IFB No. 23-32 Security Vestibules at Ellis, Lewis Lemon, RESA & Marshall Schools

RE: ADDENDUM NO. 2

Subject: **CHANGES to the BIDDING DOCUMENTS**

Project: **SECURITY VESTIBULE AT
VARIOUS SCHOOLS FOR
ROCKFORD PUBLIC SCHOOL DISTRICT #205
ROCKFORD, ILLINOIS**

3 DETAIL
SCALE: 1-1/2"=1'-0"

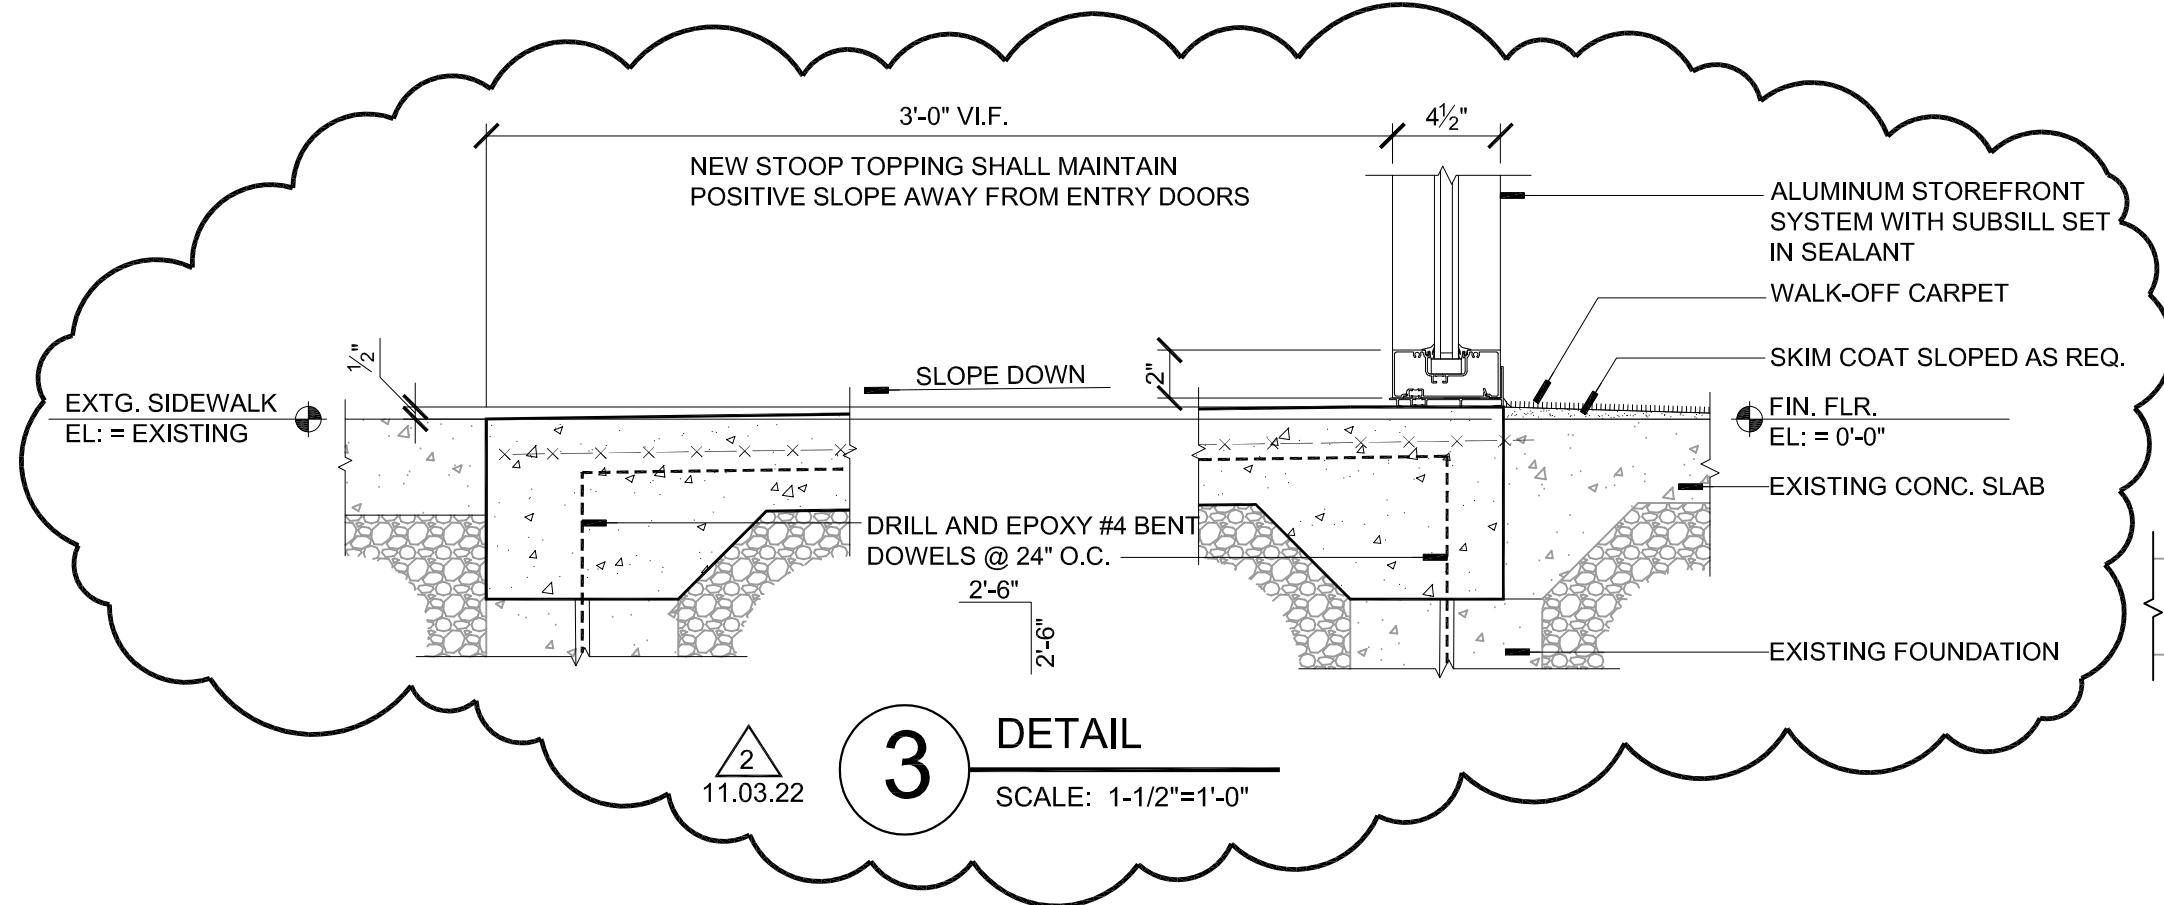
3. DRAWING A110

3.1. See added detail cut thru the stoop. See attached revised drawing.

- 40 NEW 4" THICK CONCRETE TOPPING WITH WELDED WIRE REINFORCEMENT PER ASTM A1064 - TIE INTO EXISTING FOUNDATIONS - SEE DETAIL 3/A110
- 41 SEE PLAN 3/A109 FOR PARTIAL REVISED STOOP PLAN
